Re: Feasibility Study Comments - American Chemical Services Site -
Griffith, Indiana

**ATTACHMENT 1
FEASIBILITY STUDY REVIEW COMMENTS
AMERICAN CHEMICAL SERVICES SITE
GRIFFITH, INDIANA**

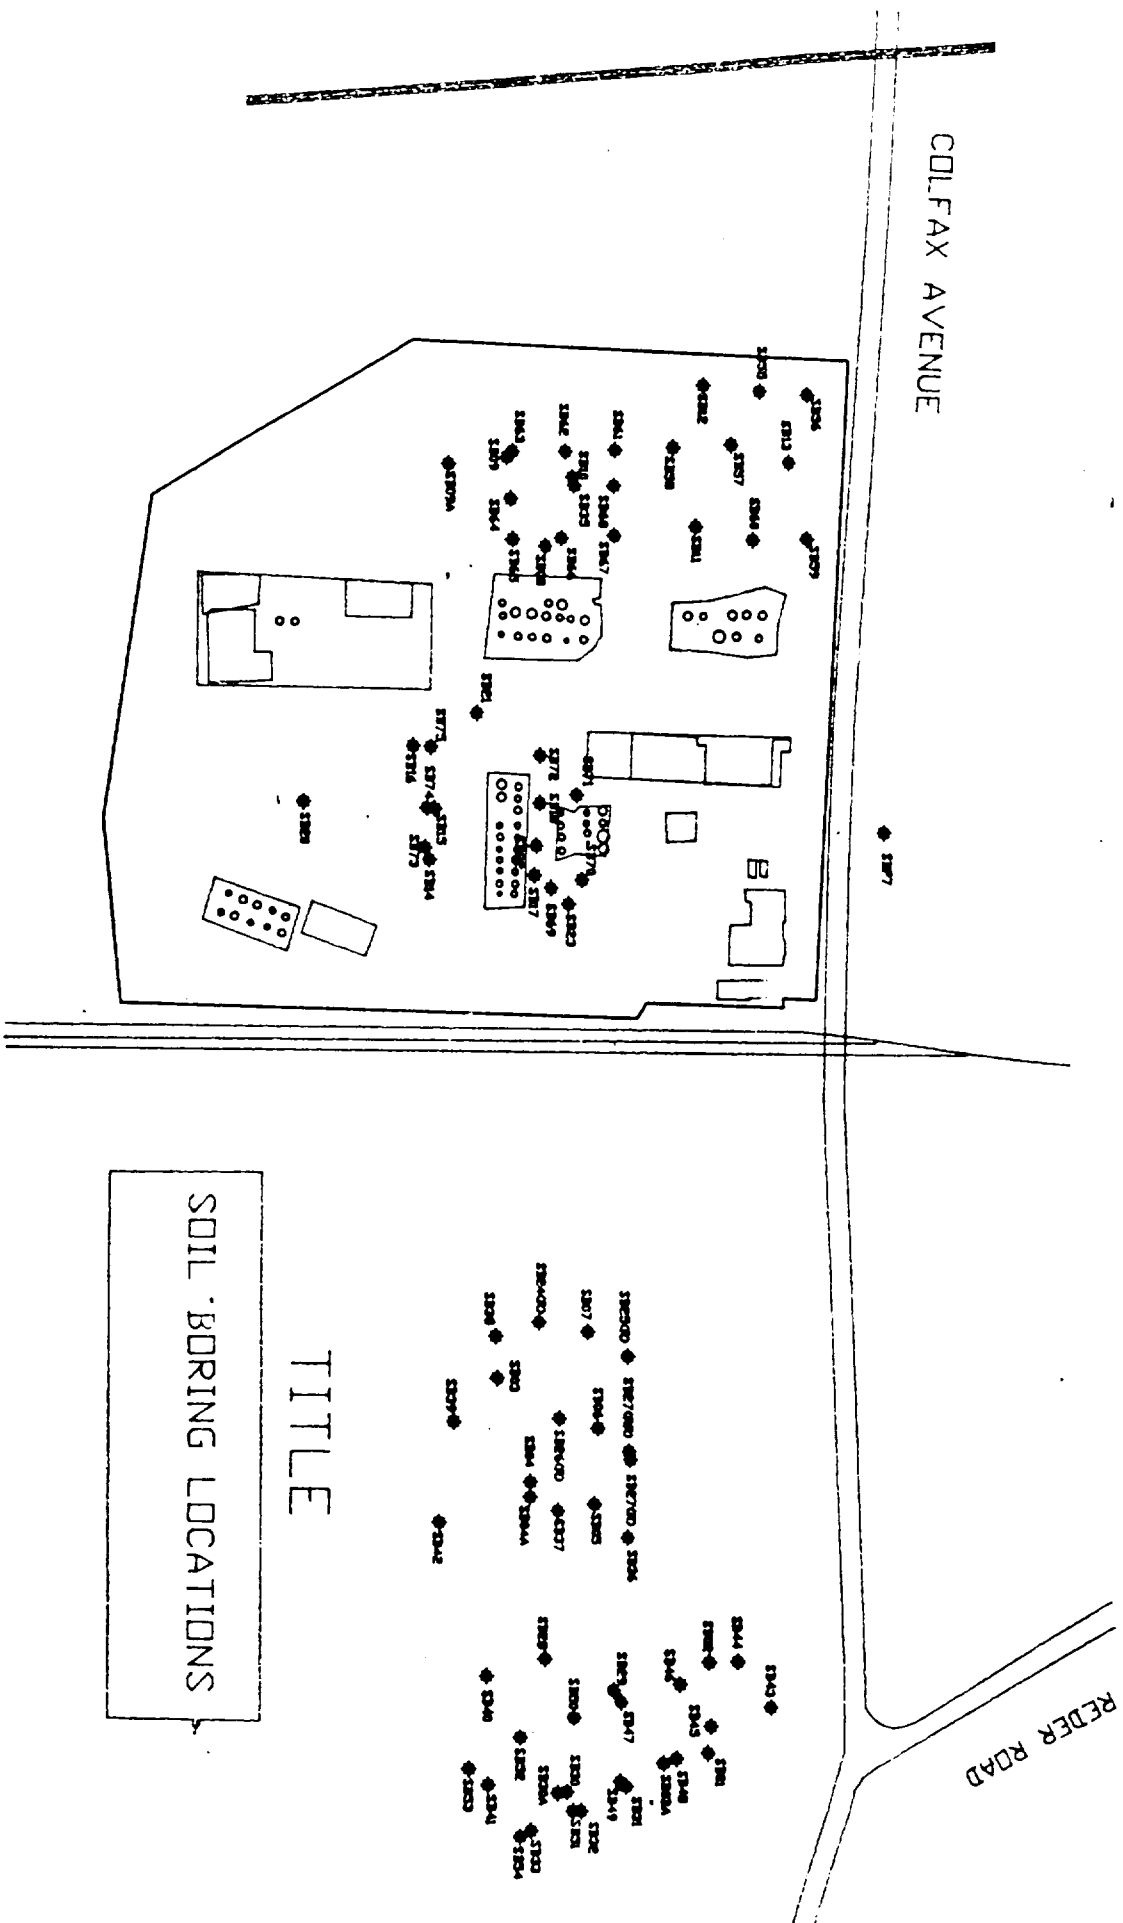
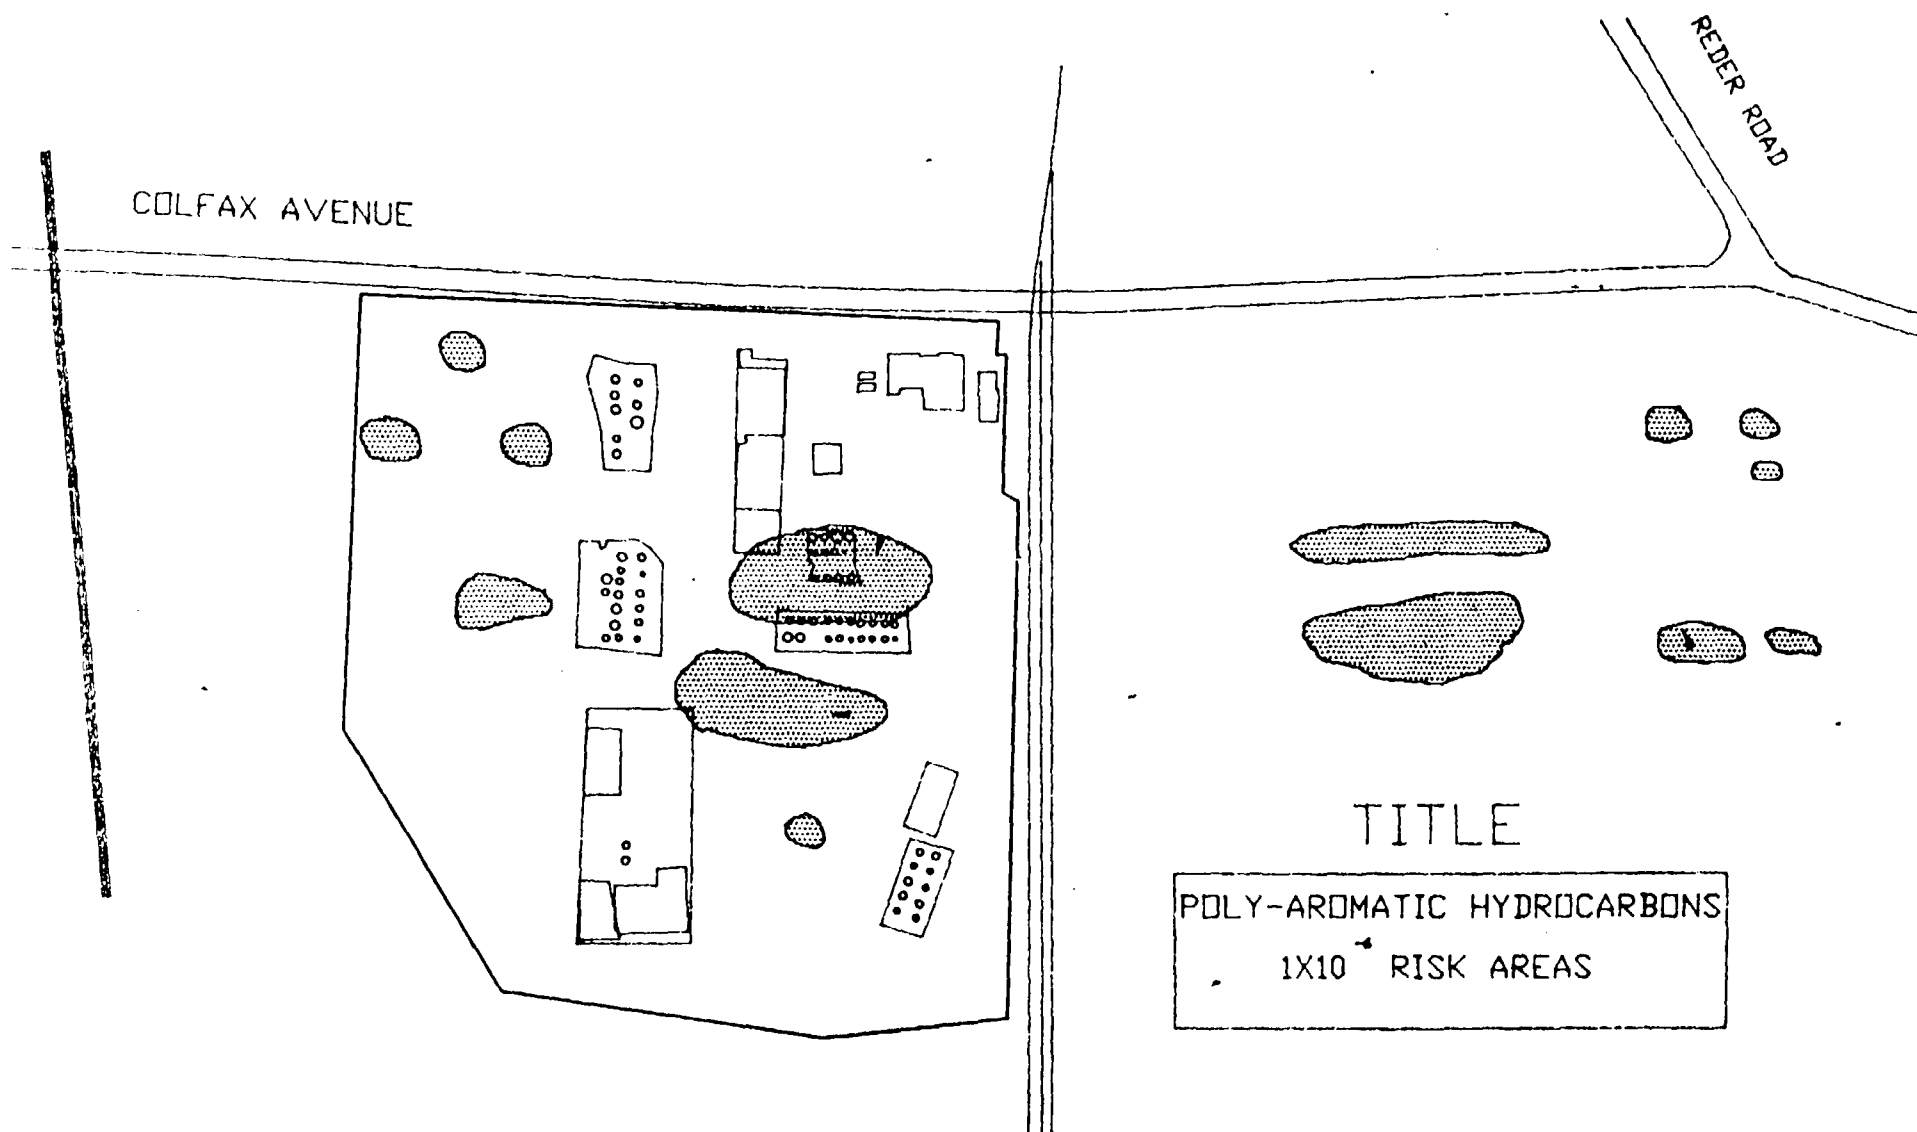
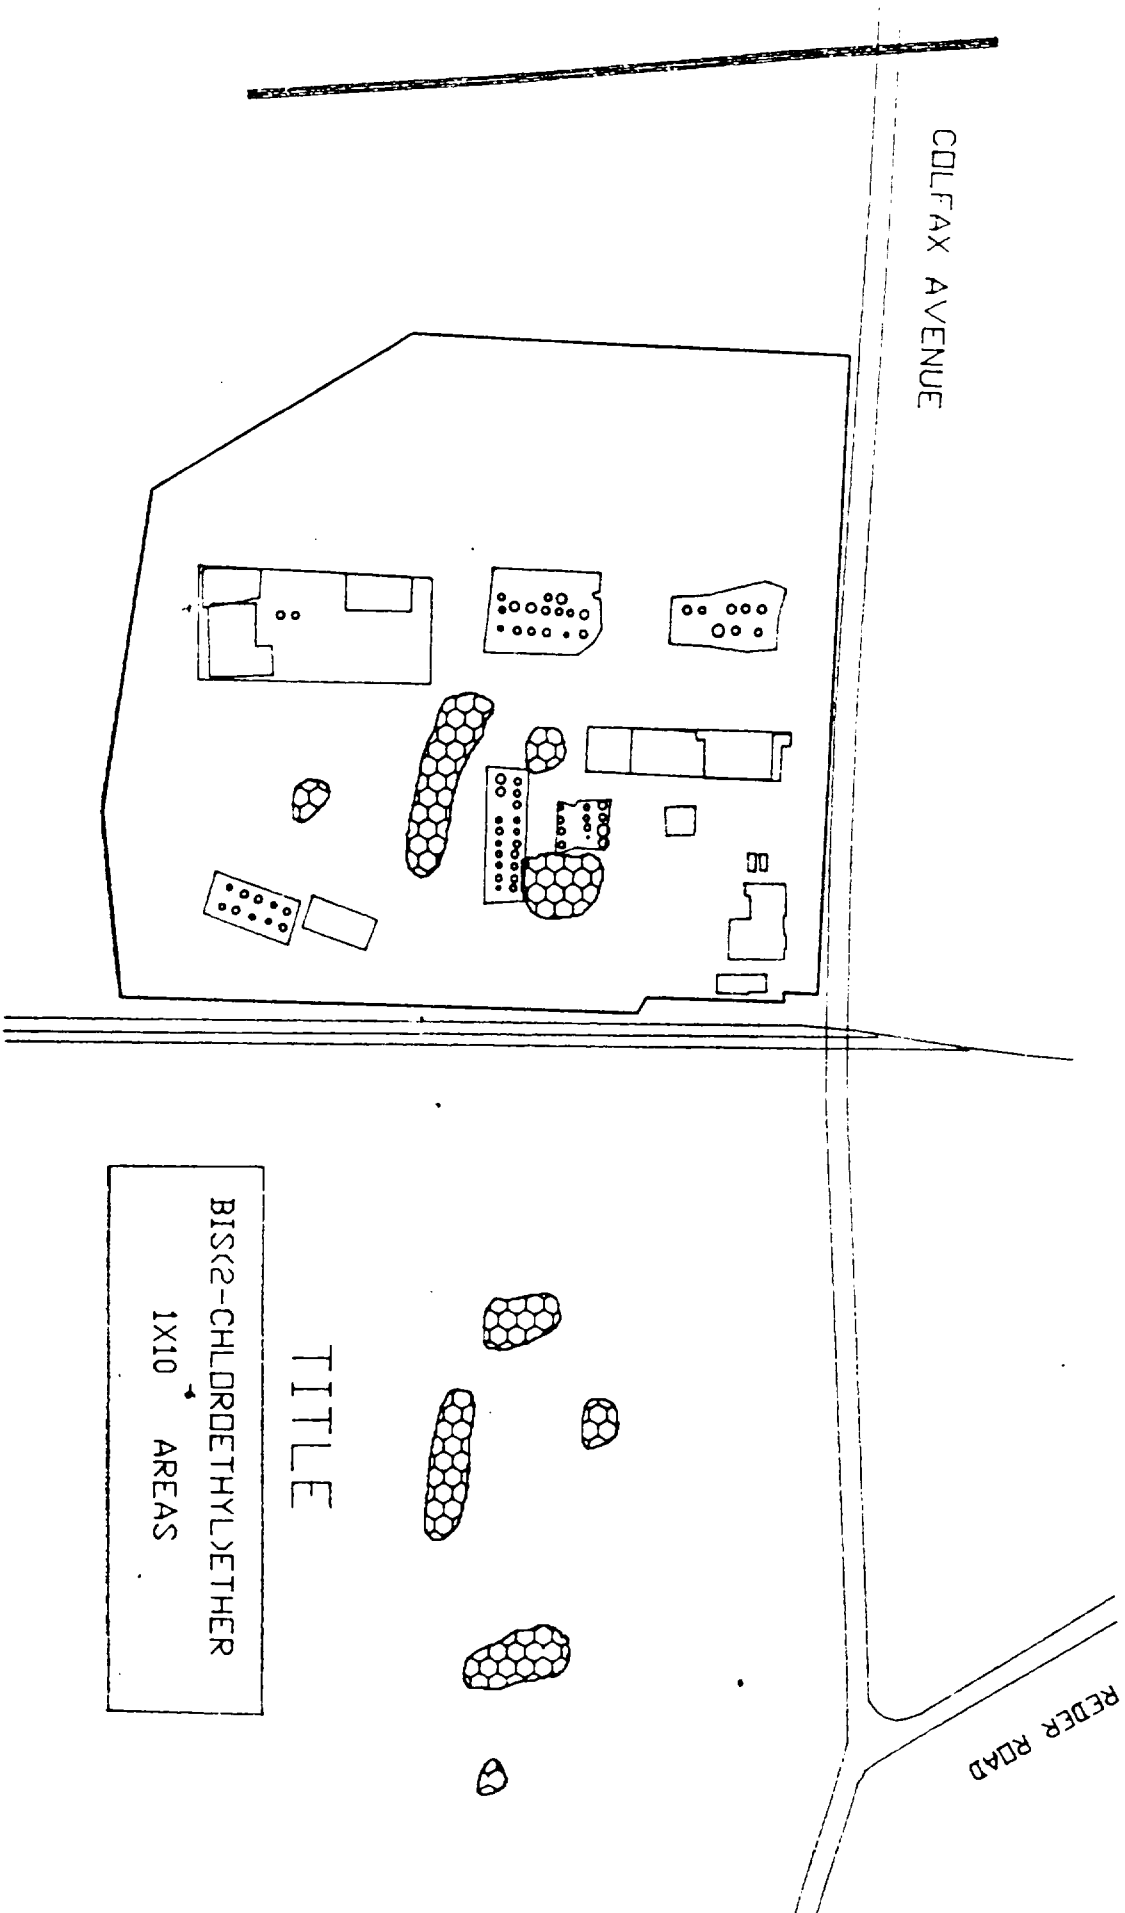
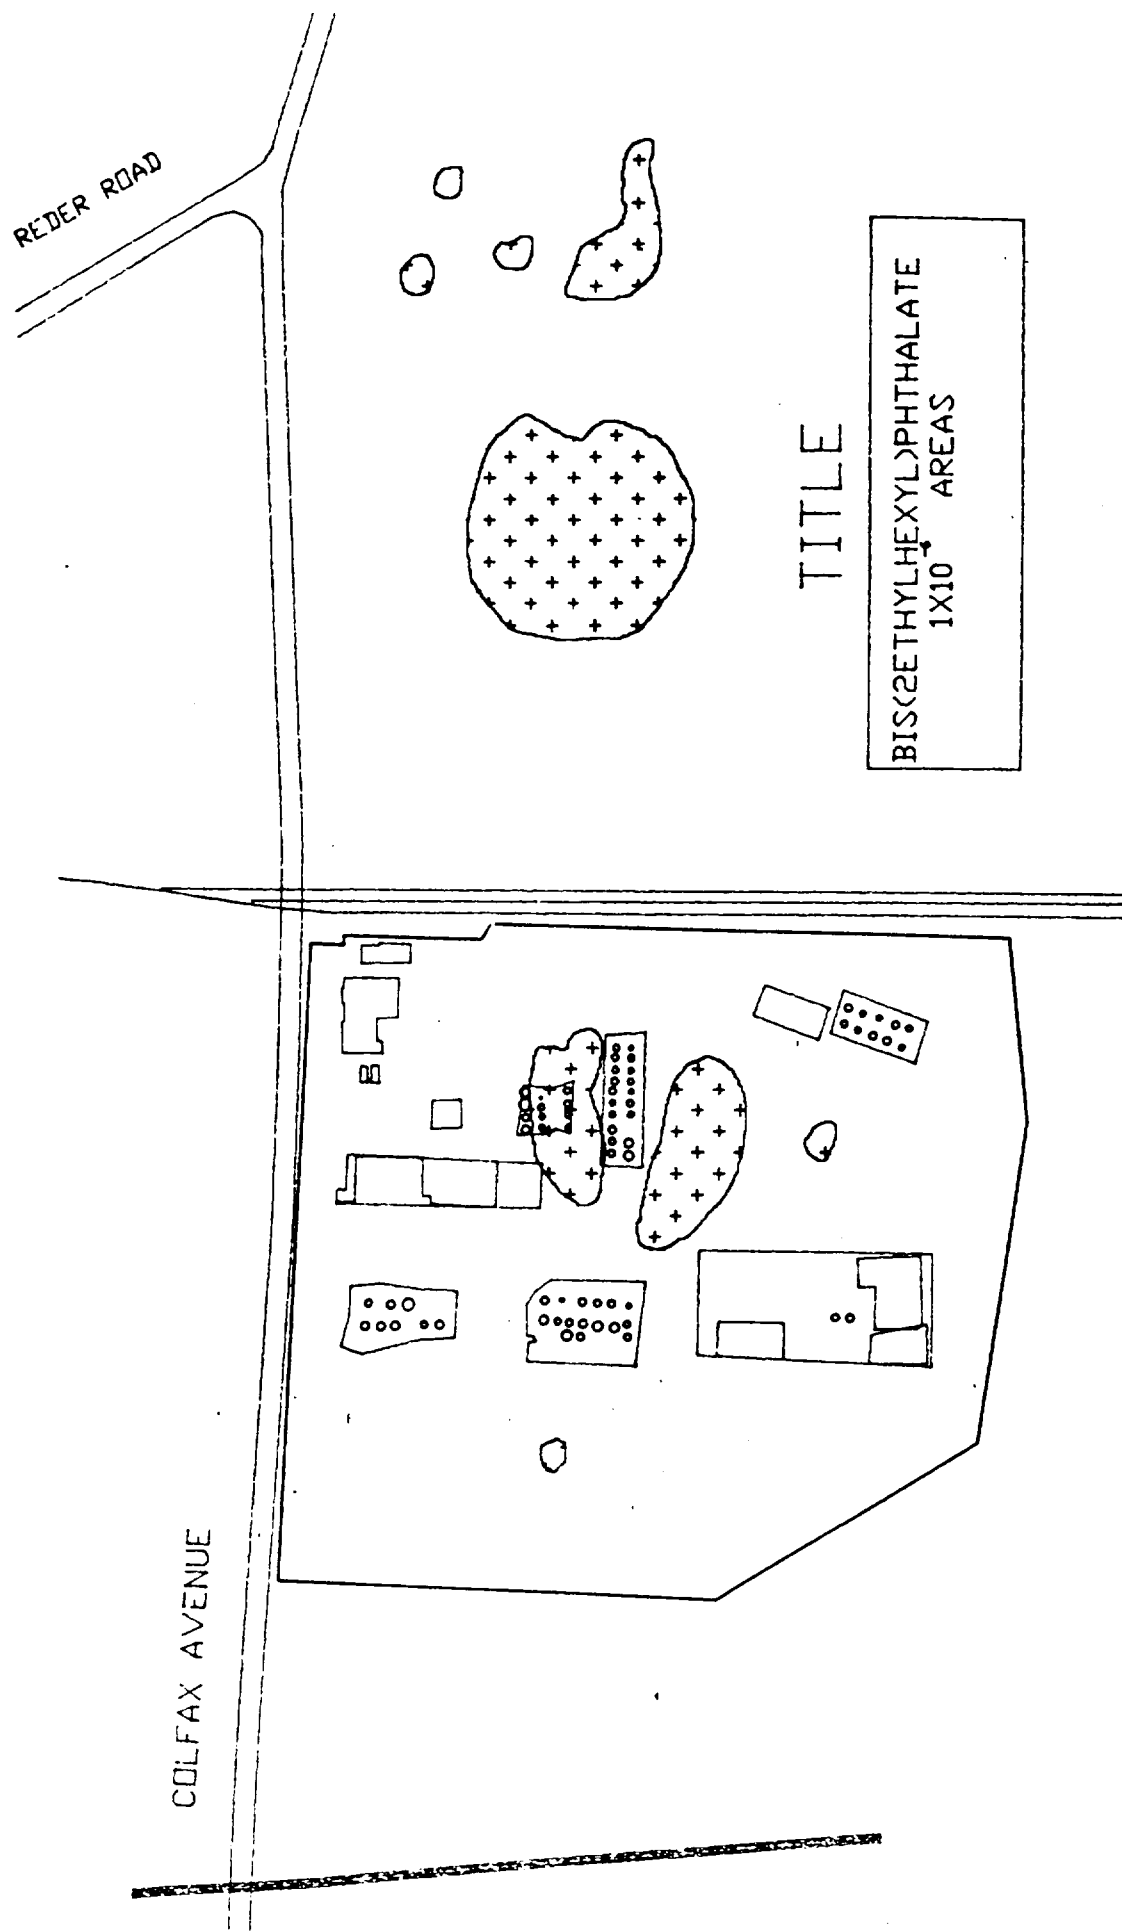
In general the cost estimates seem reasonable and probably fall within the -30%, +50% FS cost estimate guideline. However, in the following comments you will find requests for the basis of the cost estimates. It was expected that more backup information (cost assumptions, vendor quotes, etc.) would have been provided. This backup information could be provided on a notes page attached to each alternative and would allow the reviewer to feel more comfortable about the cost estimate for each line item. Attachment 5 is an example of the amount of detail which is expected for the cost estimates.
